**ANGEL PLACE
LEVEL 8, 123 PITT STREET
SYDNEY NSW 2000**

SITE COMPATIBILITY CERTIFICATE | REQUEST FOR FURTHER INFORMATION - 70 ASHFORD AVENUE, MILPERRA

This letter is submitted by Urbis Pty Ltd (**Urbis**) on behalf of Bankstown Golf Club (**the Proponent**) in response to the letter from the NSW Department of Planning, Industry & Environment's (**DPIE**) dated 7 May 2020 requesting additional information supporting the application for a Site Compatibility Certificate (**SCC**) at the above address (SCC_2019_CBANK_002_00).

Figure 1 Flowchart Identifying Cumberland Plain Shale Woodlands & Shale Gravel Transition Forest

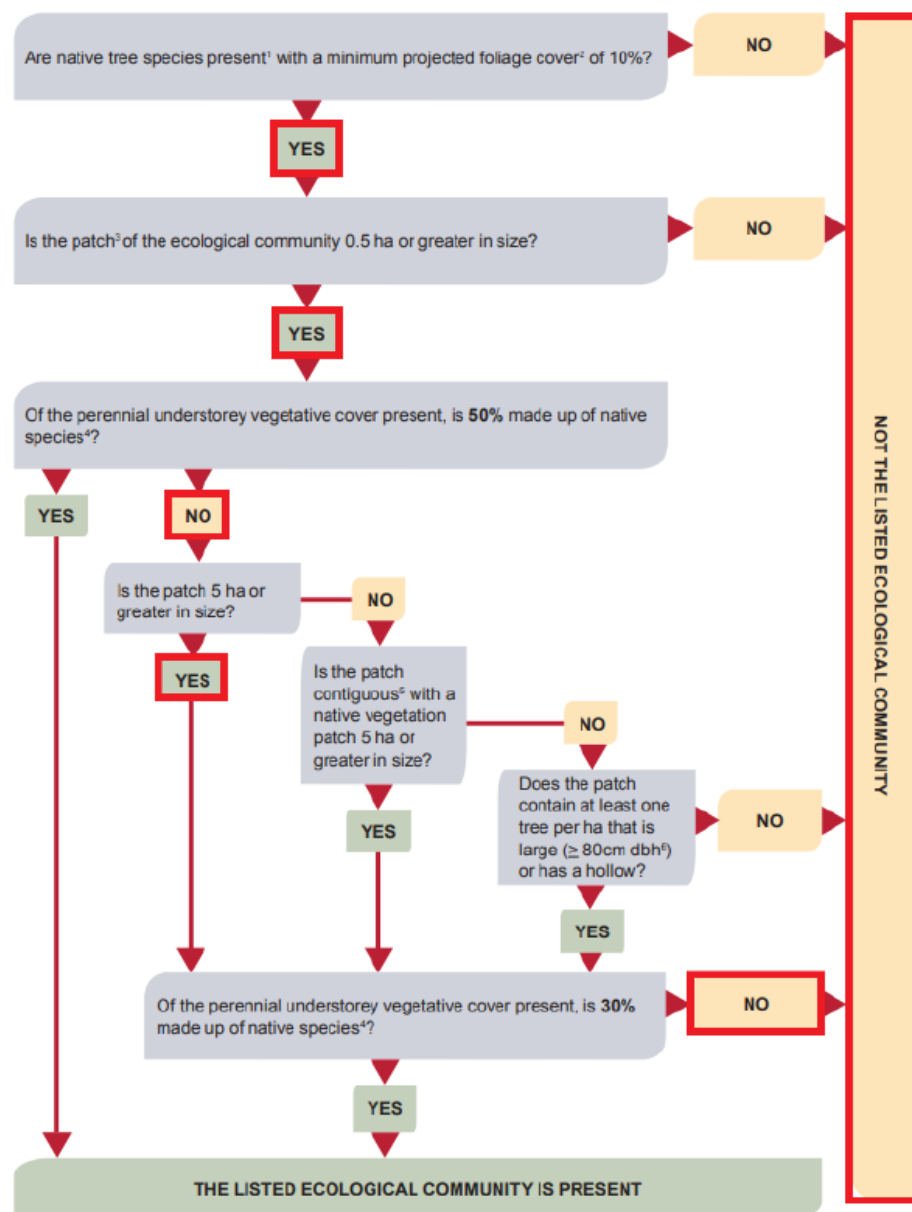
Regarding the Shale Gravel Transition Forest that was identified on site, whilst this is an endangered species under the *Biodiversity Conservation Act 2016*, for recognition as an endangered ecological community under the *Environment Protection and Biodiversity Conservation Act 1999* definition, the vegetation must meet selected criteria. This criterion is demonstrated below as **Figure 1**.

The existing community of Shale Gravel Transition Forest on site ultimately does not comprise a perennial understory of 30% or more in native species (Question 5 above), as such the existing vegetation is not commensurate with the *Environment Protection and Biodiversity Conservation Act 1999* definition of community, and thus is not an endangered ecological species.
